## IS F

### OUTLINE OF NEW FEATURES

The following changes have been made for the 2011 model year.

## 15. Seat Belt Warning System

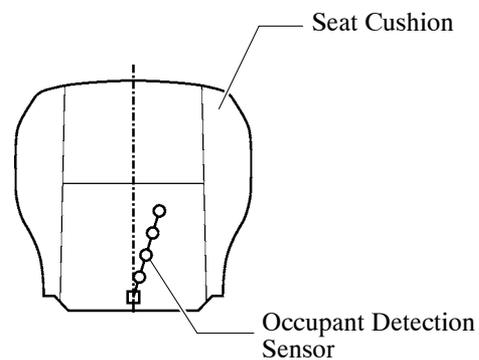
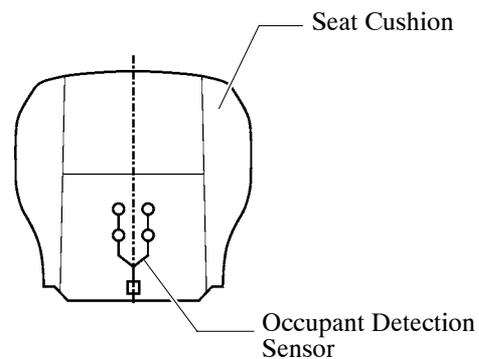
- A seat belt warning buzzer on/off display function has been added to the multi-information display. For details, see page 22.
- The occupant detection sensor has been changed from a 4 cell parallel circuit type to a 2 cell series circuit type to secure occupant detection on the destination package for South Korea.

## 16. Pre-collision System

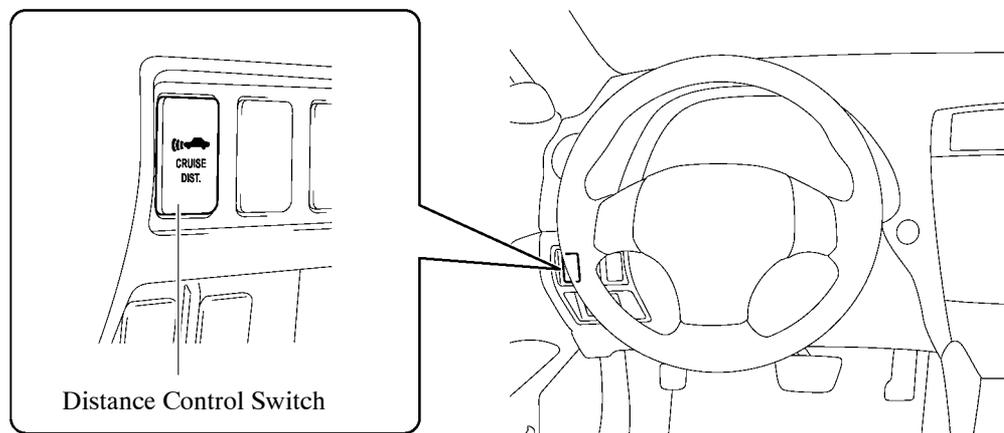
Pre-collision brake control has been adopted on models for U.S.A. and Canada. For details, see page 26.
